Addendum #1 for
St. Joseph University Catholic Parish
Terre Haute, IN
Parish Hall
September 15, 2026

entheos ARCHITECTS
802 Lord Street, Ste. 200
Indianapolis, IN 46202
Ph (317) 951-9590

CHANGES TO THE DRAWINGS

2 Column Framing Detail
Scale: 1-1/2" = 1'-0"

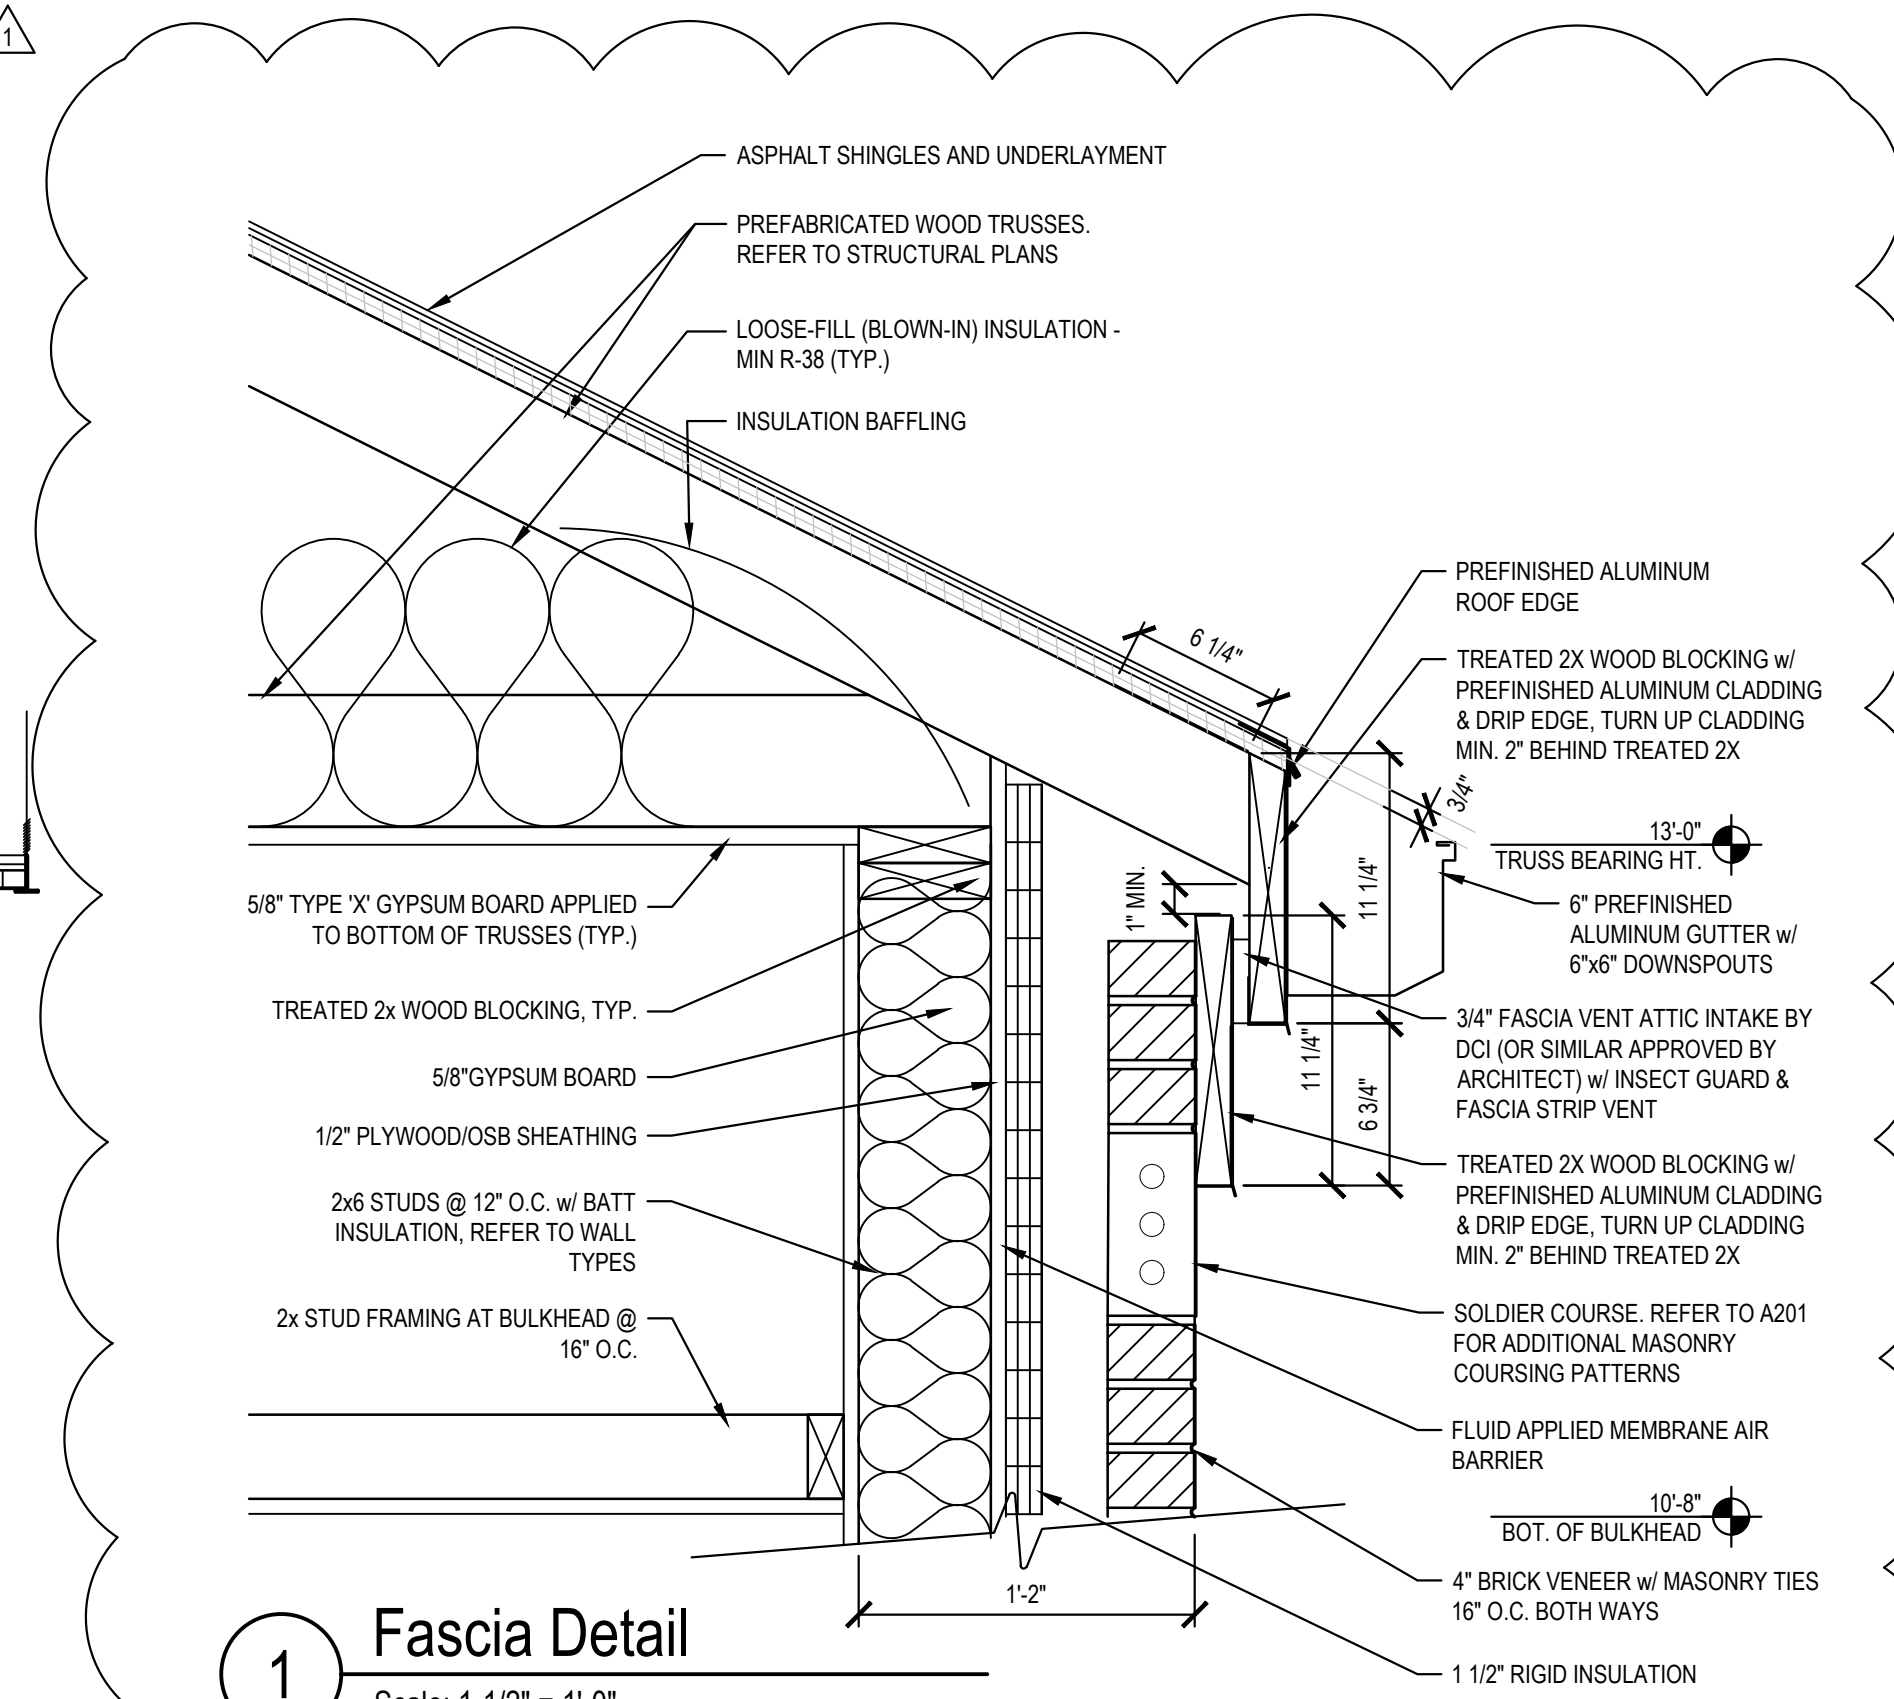
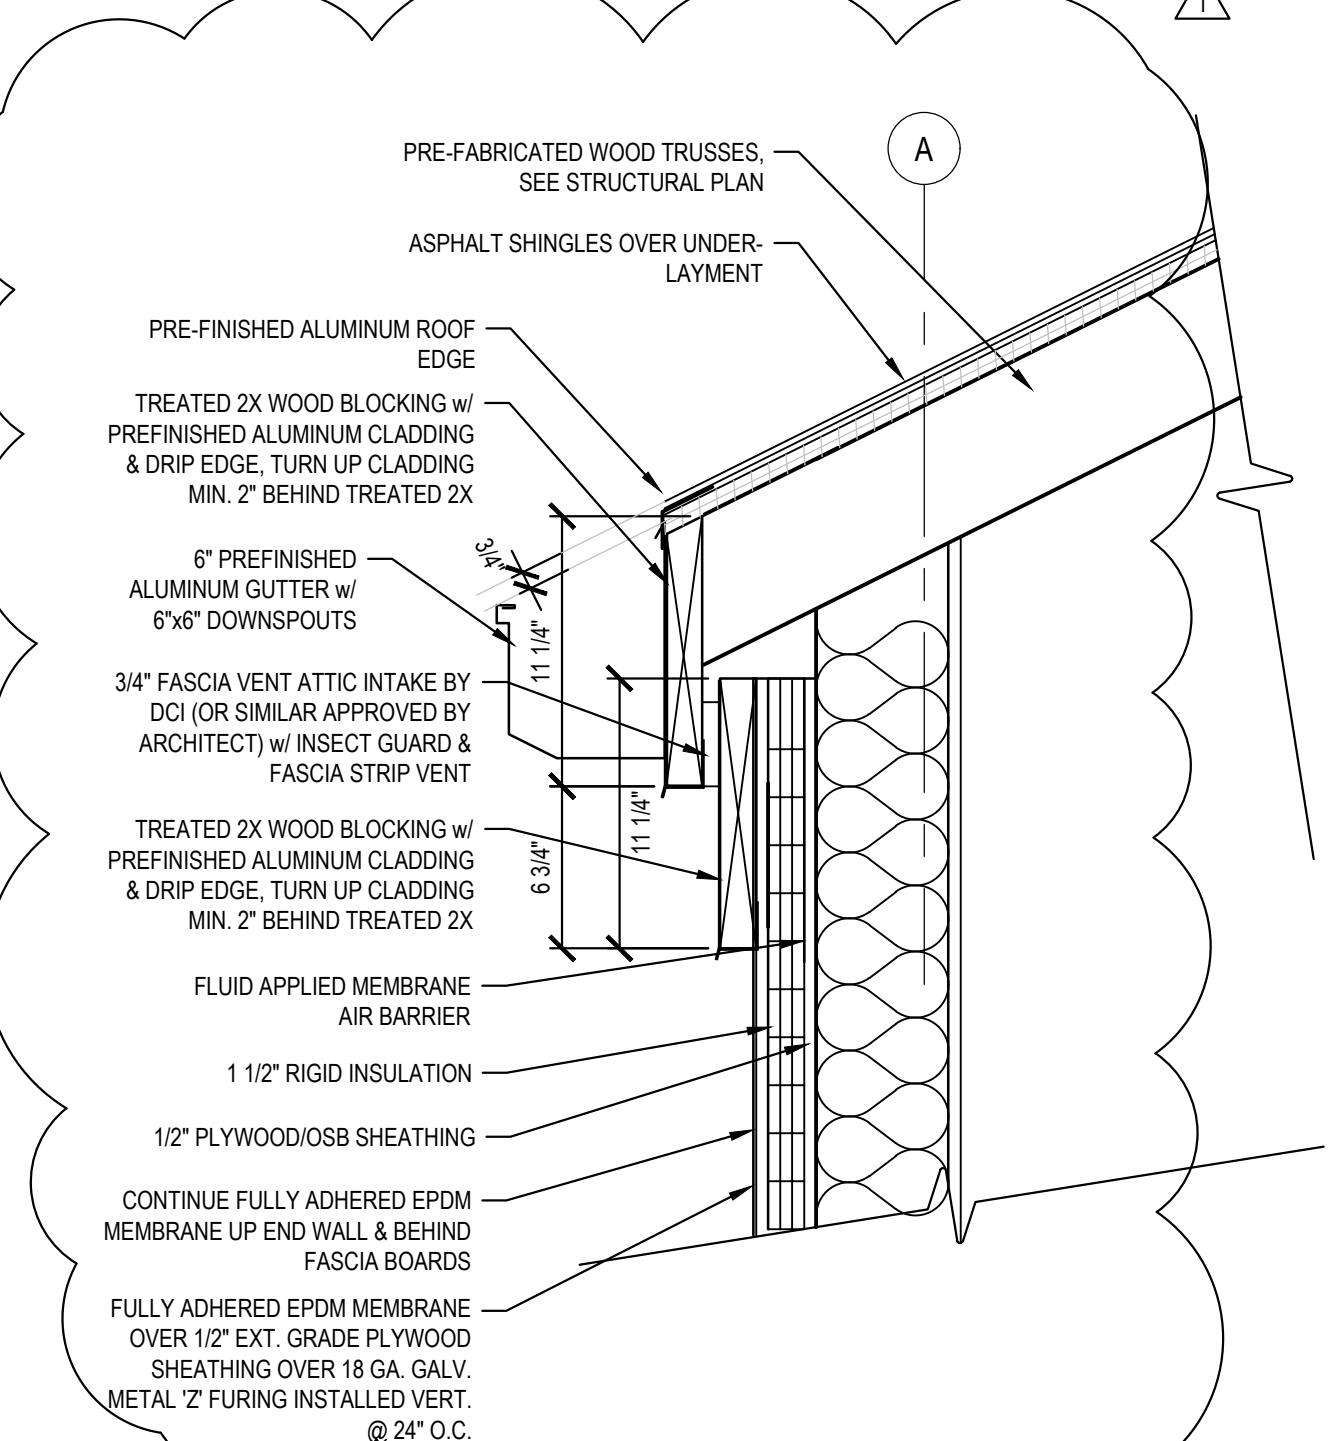
1. Revise Details as shown. Replace sheet in entirety.

Sheet A304 - Details

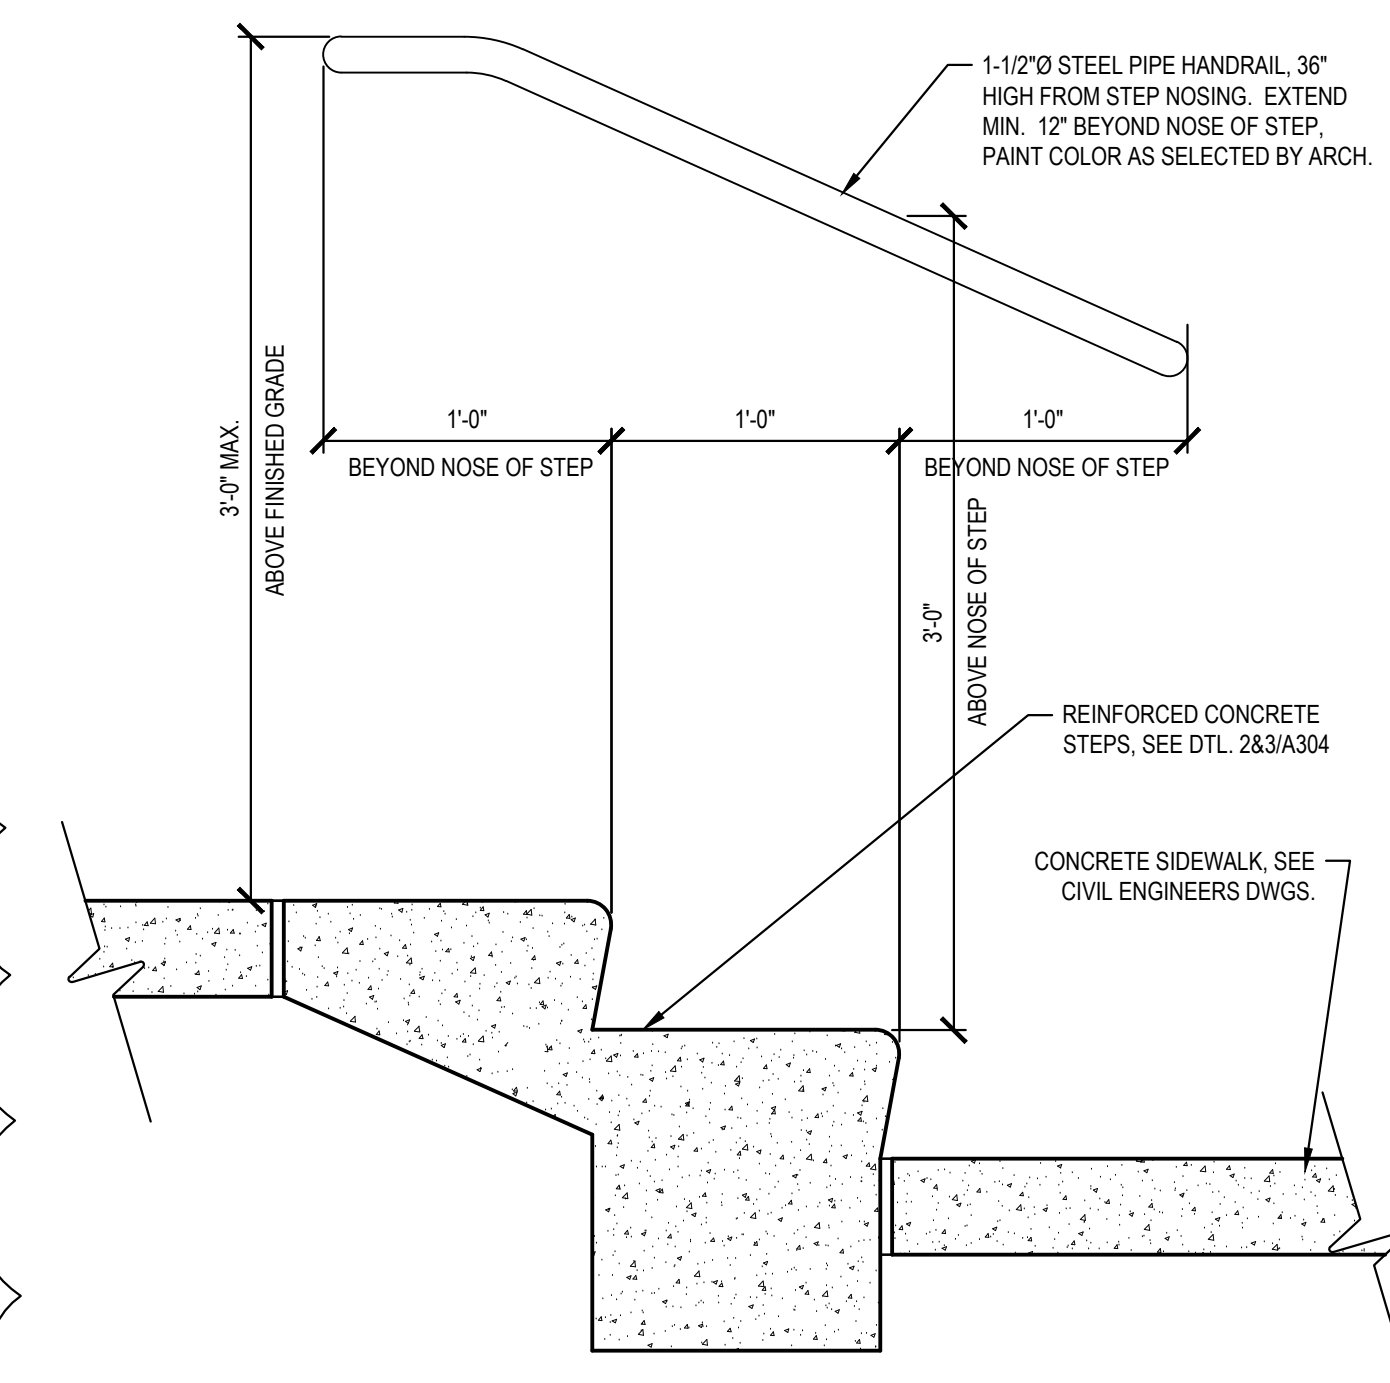
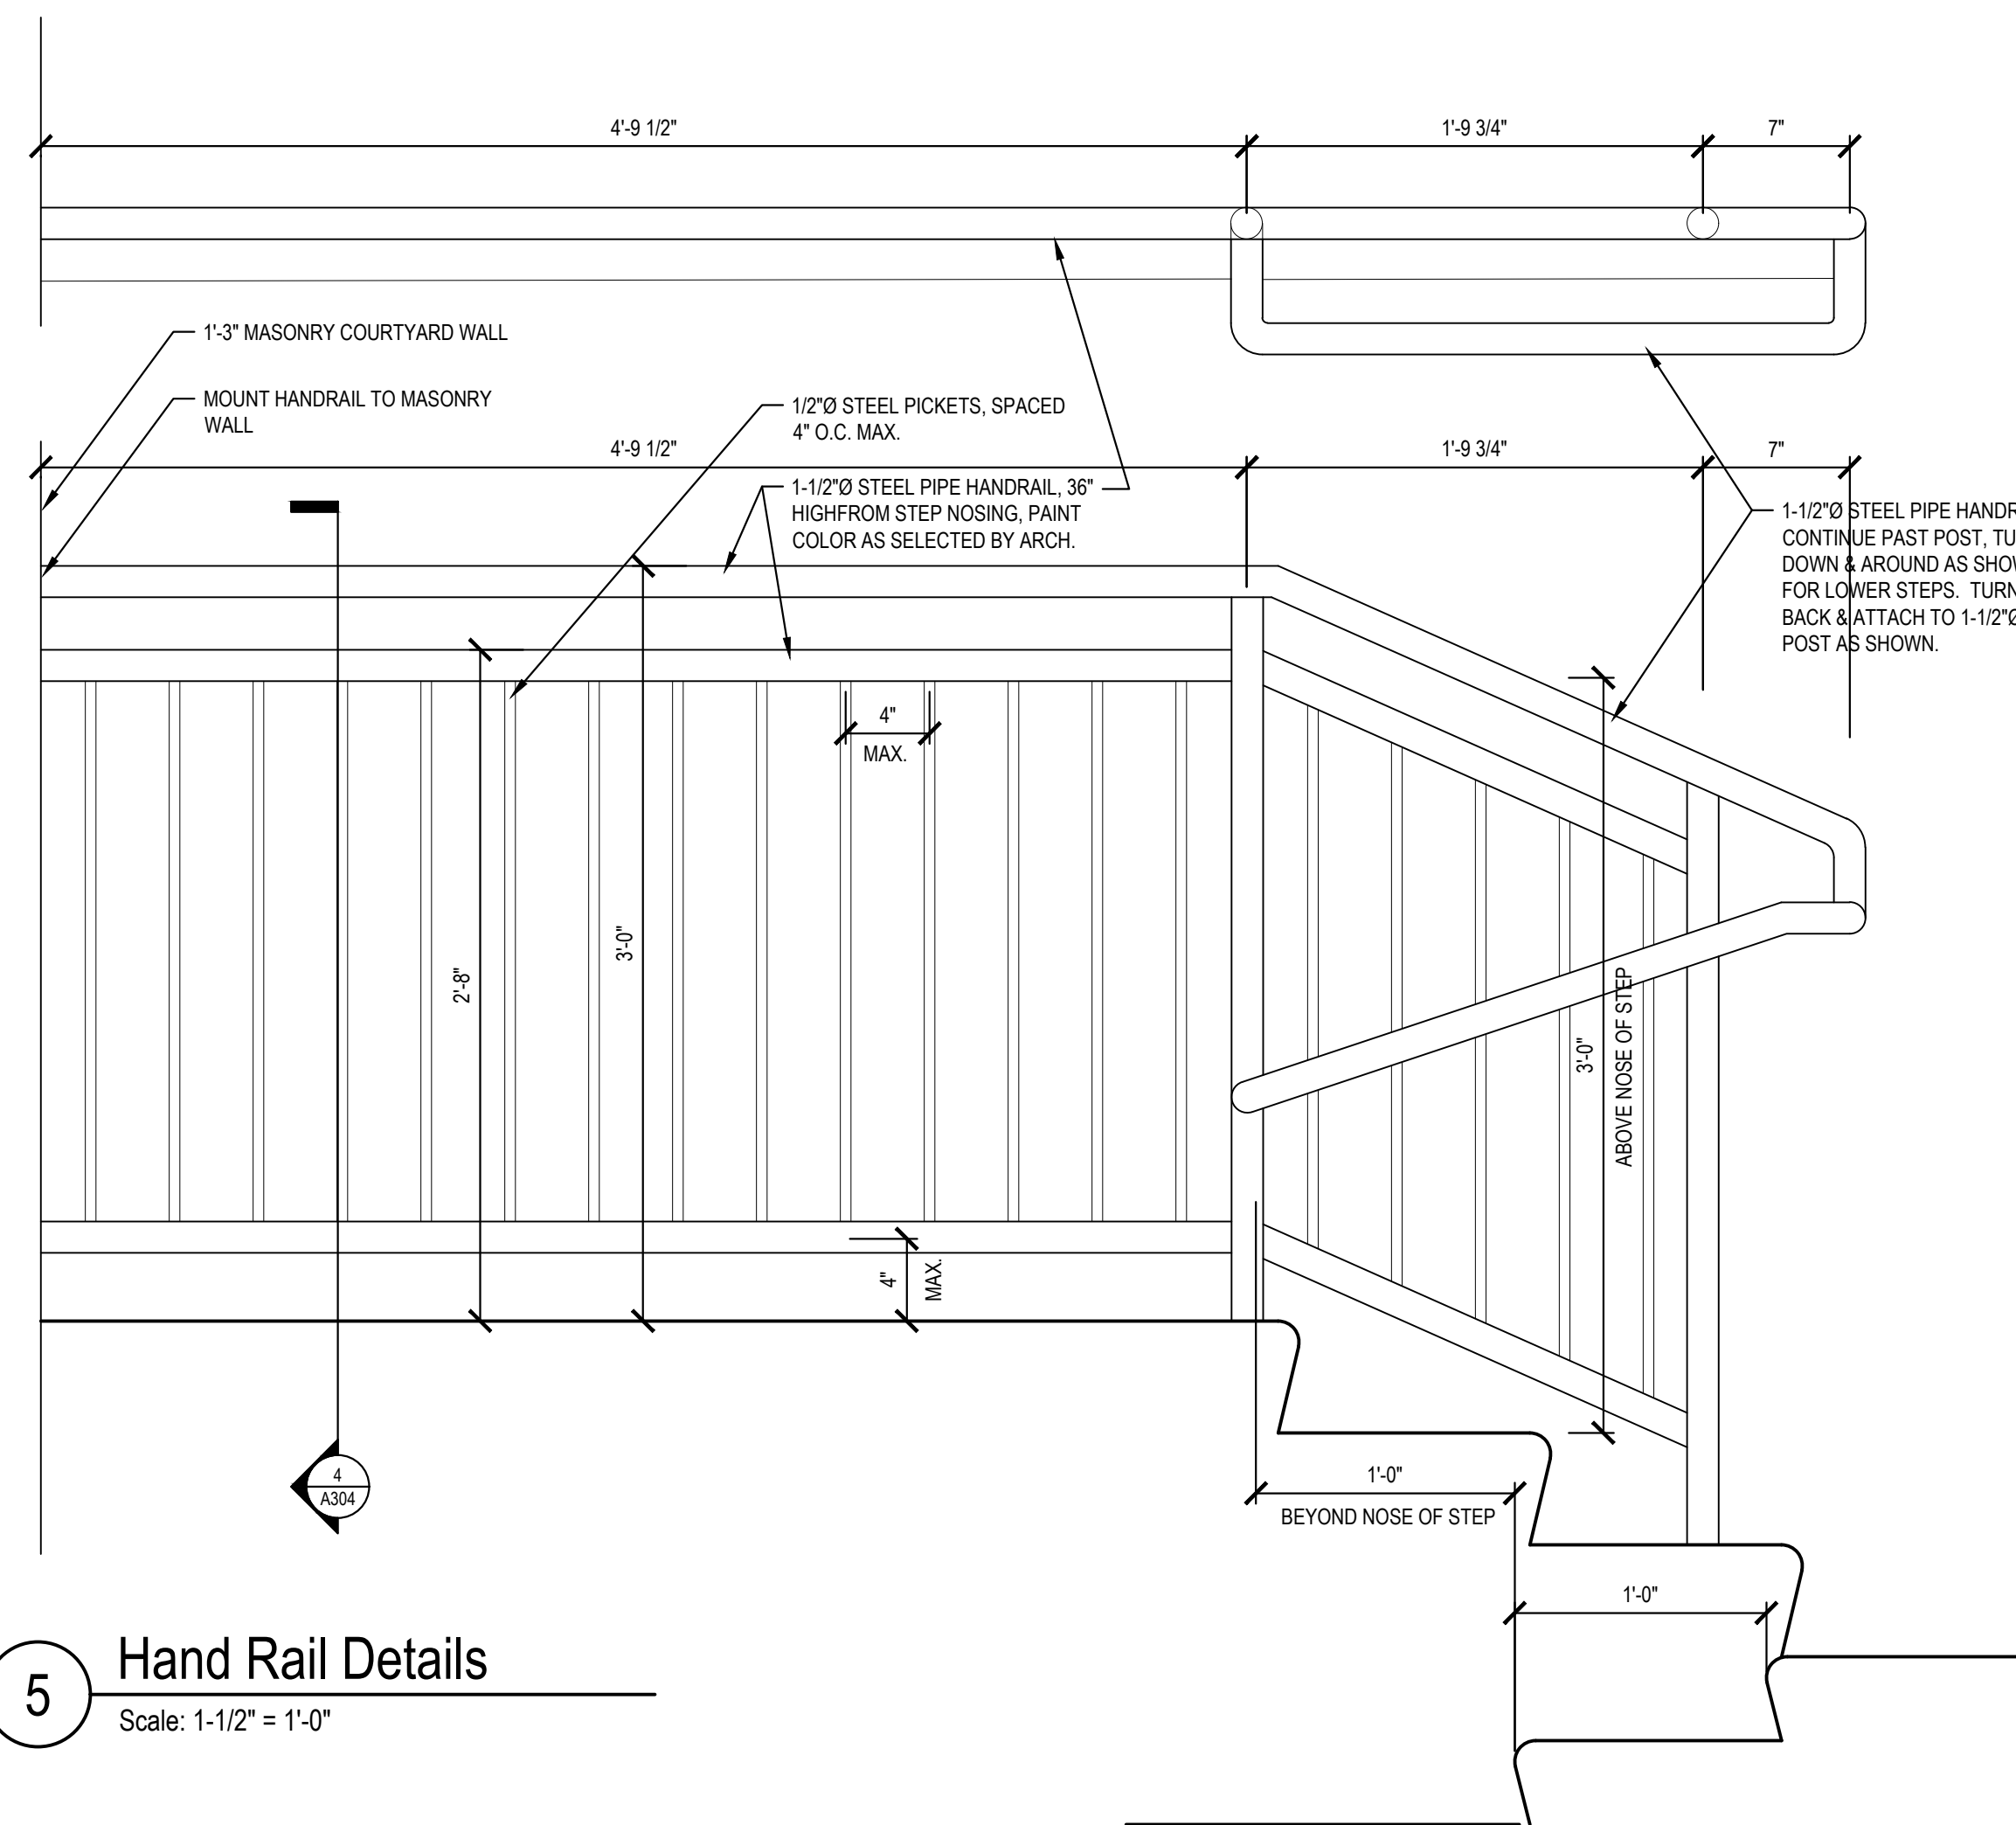
2. Revise Step and Railing Details. Replace sheet in entirety.
